Response to 9-21-05 OA

U.S. Serial No. 10/721,467

Amendment

## **AMENDMENTS TO THE DRAWINGS**

FIG. 4

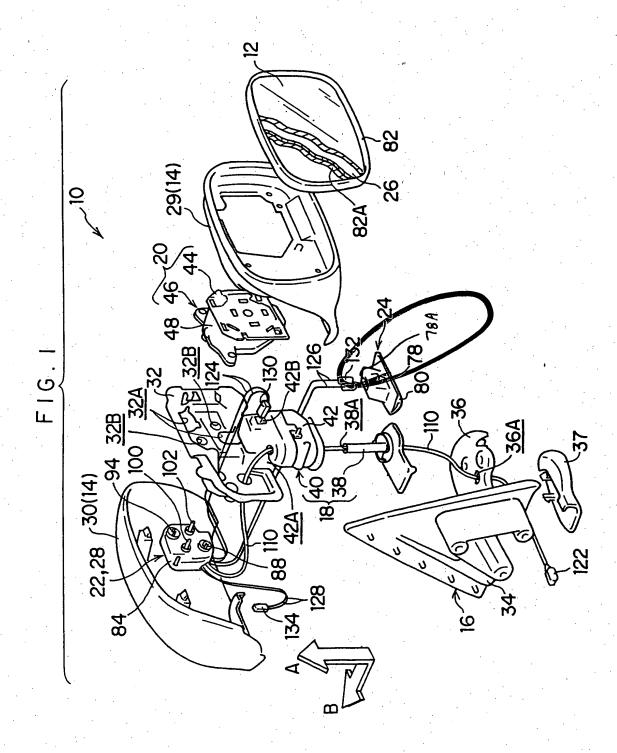
Figures 1 and 4 of the attached drawing sheets include changes to incorporate reference numerals 78A, 105 and 107. Figure 9 has also has been amended to include the legend "PRIOR ART".
